## City of Lawrence

**RE:** MISC NO. 1; VARIANCE FOR CERTIFICATE OF SURVEY; 120 HWY 40(MKM)

**CSR-13-00496:** Consider a variance associated with a Certificate of Survey requested from Section 20-806(d)(2)(i) of the Subdivision Regulations [Section 11-106(d)(2)(i) of the County Code] to allow the creation of a Residential Development Parcel with a minimum width less than required. Submitted by Howard Smith, for Howard and Fredonna Smith property owners of record.

**Figure 1.** Certificate of Survey with both RDPs having required frontage and 90% minimum parcel width. Frontage for both RDPs is shown with arrow A, and the minimum parcel width is shown with arrow B. (hatched area is not included in the Certificate of Survey).

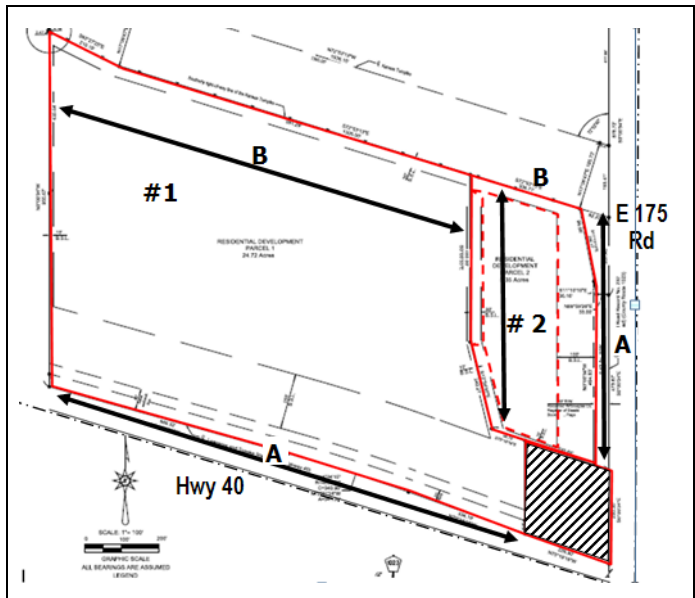
This Certificate of Survey will create 2 Residential Development Parcels on approximately 30 acres. The property is developed with one residence and outbuildings and RDP 2 will be available for additional residential development. RDP 1 has frontage on Hwy 40, a principal arterial; therefore, a minimum frontage of 1320 ft and a minimum parcel width of 1188 ft is required (Per Section 12-318 of the Zoning Regulations). RDP 2 will take access to E 175 Road, a major collector, and is required to have a minimum frontage of 500 ft and a minimum parcel width of 450 ft. With the layout shown in Figure 1, both RDPs are able to comply with these requirements; however, as shown in the next section of this memo, RDP 2 does not have a suitable building area due to topography of the site.

width of 1188 ft for RDP 1 limits the depth of RDP 2 as shown in Figure 1. Providing the depth for RDP 2 which is necessary to provide a buildable area would reduce the minimum width of RDP 1 to approximately 620 ft. (Figure 3)

**STAFF RECOMMENDATION:** Staff recommends approval of the variance requested from Section 20-806(d)(2)(i) of the Subdivision Regulations [Section 11-110(d)(2)(i) of the County Code] to allow a land division through Certificate of Survey CSR-13-00496 with RDP 1 having a minimum parcel width of 619.88 ft rather than the 1188 ft required by Code subject to the following condition:

1. The following note shall be added to the Certificate of Survey:
  - a. *"At their April 21, 2014 meeting, the Planning Commission approved a variance from Section 20-806(d)(2)(i) of the Subdivision Regulations to allow a minimum parcel width of 619.88 ft for RDP 1."*

**Figure 2a.** RDP #2 with building envelope outlined in dashed line. Contours shown in yellow.

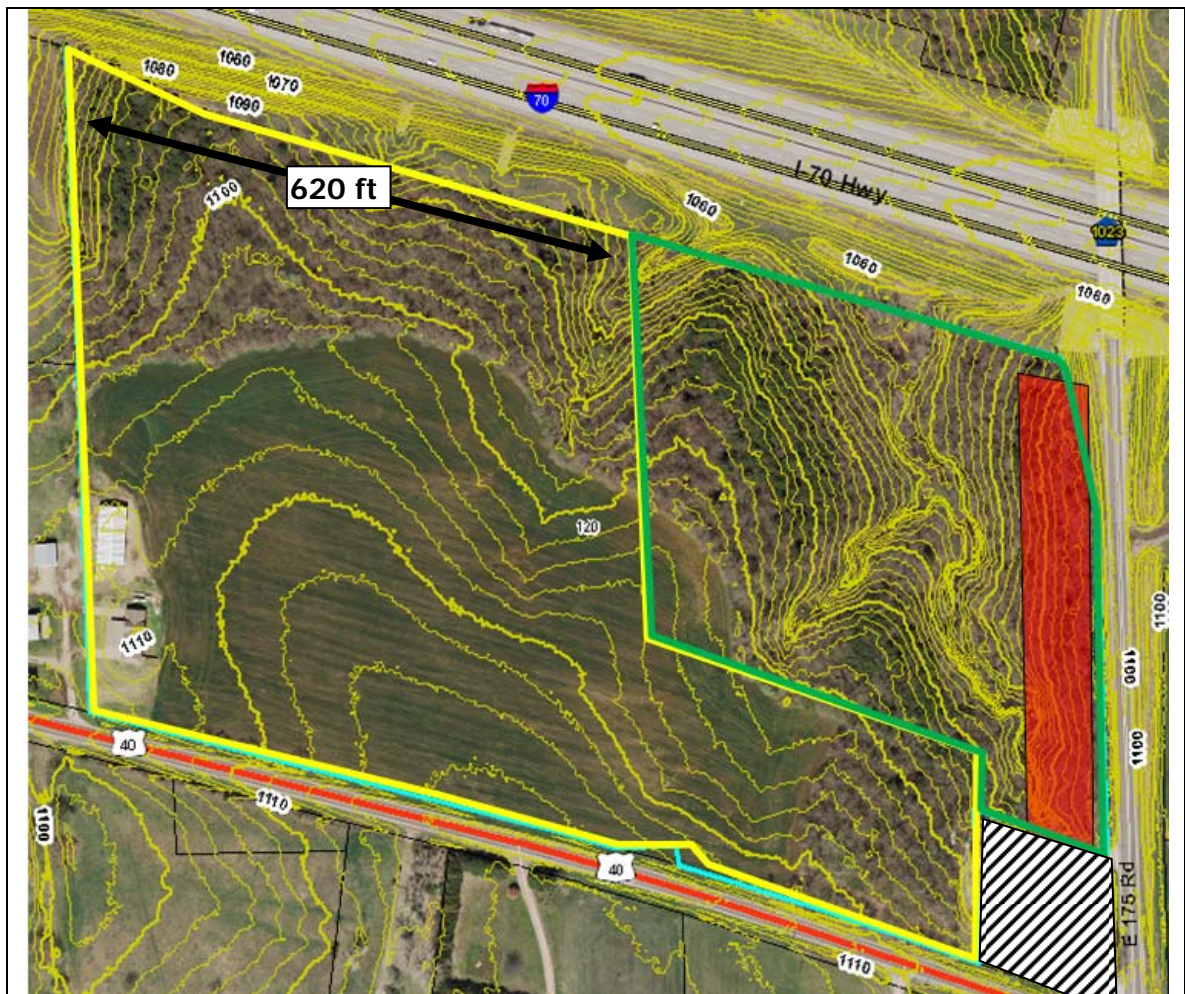
The strict application of these regulations would result in the creation of a Residential Development Parcel that would be very difficult to develop due to the topography of the site. To illustrate, Figure 2a shows an aerial photo with contours and 2b provides slope information from the City GIS maps. Slopes between 7% and 15% are shown in brown and slopes 15% and higher are in red. The steepest slopes are located within the center of the building envelope.

Strict application of the regulations would require the creation of a RDP which, due to the topography of the site and the required building setbacks, would have a very limited building area. This hardship would be unnecessary as it is possible to reconfigure the parcels with a variance to the minimum parcel width requirement and create 2 RDPs suitable for development.
